Agenda Item: 4.3
Source: Nokia
Title: **CR to 25.303 on removal of FFS in DSCH transmission example**
Document for: Approval

25.303 CR 00?

Subject: Removal of FFS in DSCH transmission example

Figure 1: Example of acknowledged-mode data transmission on DSCH

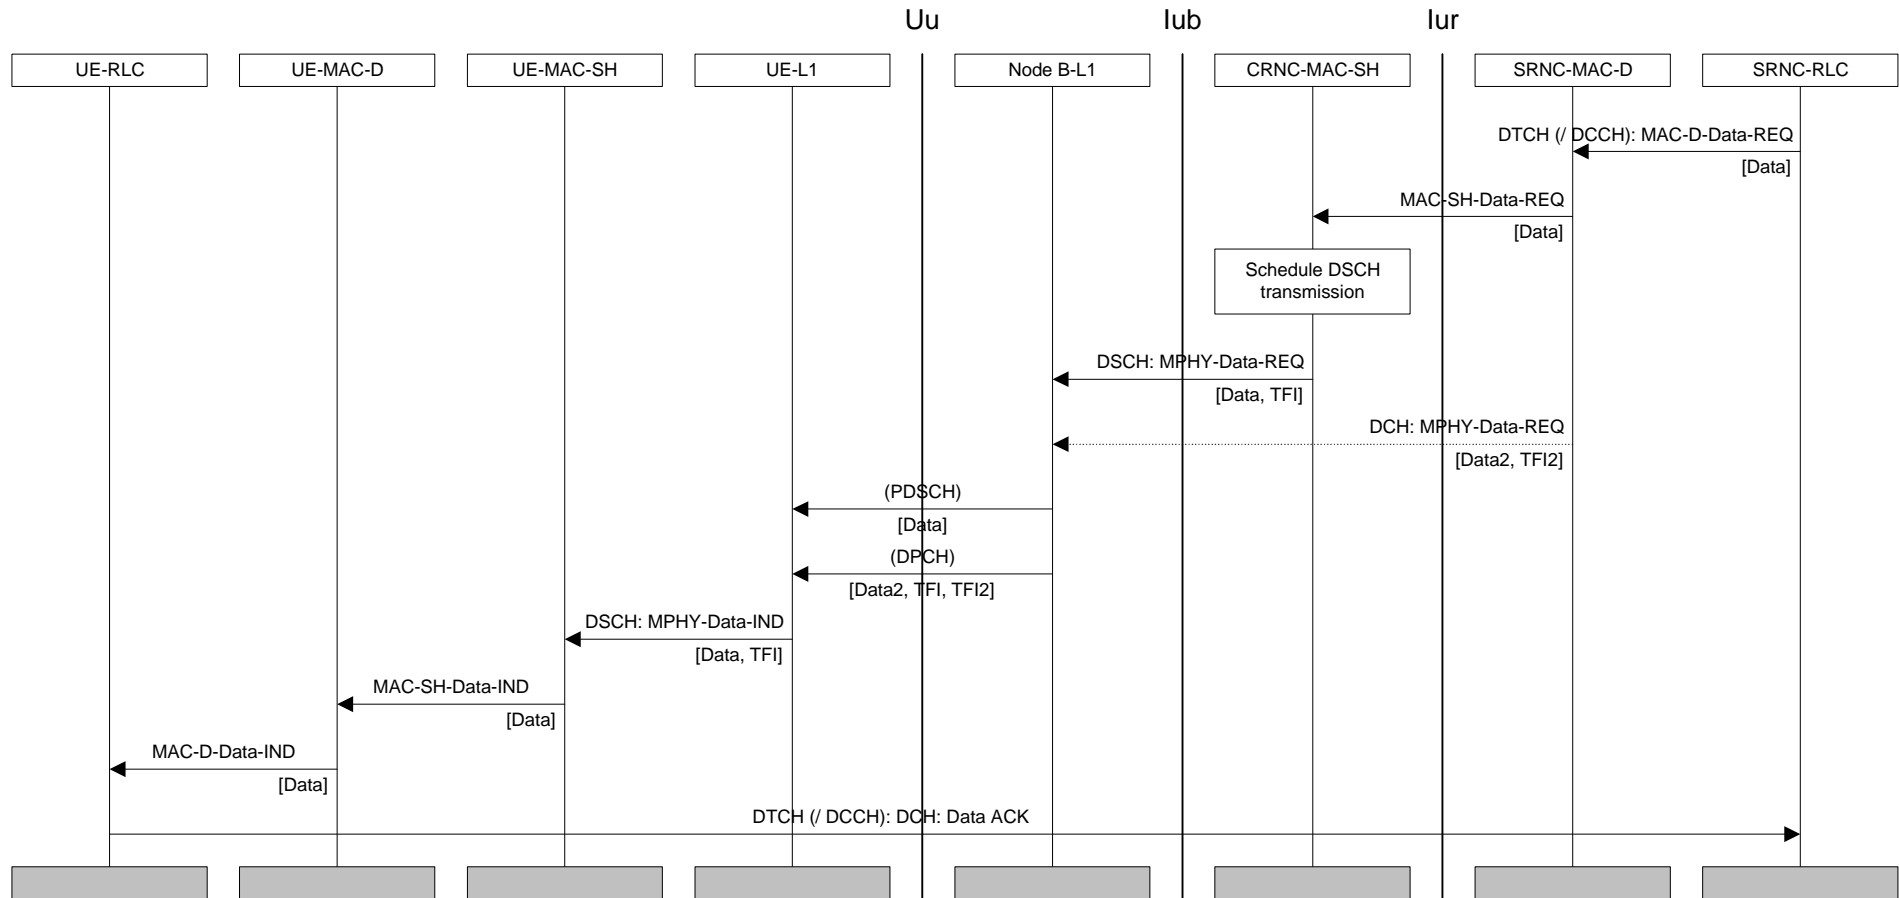
Reason for change: Removal of FFS pending on RAN WG1 confirmation from DSCH downlink data transmission.

[Editor's note: This example is currently FFS, pending confirmation from WG1 on the use of independent parts of TFCI with different active sets.]

RAN WG1 has included into the specification the possibility for not sending the code words corresponding for the DSCH activity from all downlink links (liaison Tdoc RAN WG2 534/99). FFS pending on this reply from RAN WG1 can now be removed from the example on downlink data transmission on the DCH / DCH + DSCH in 25.303.
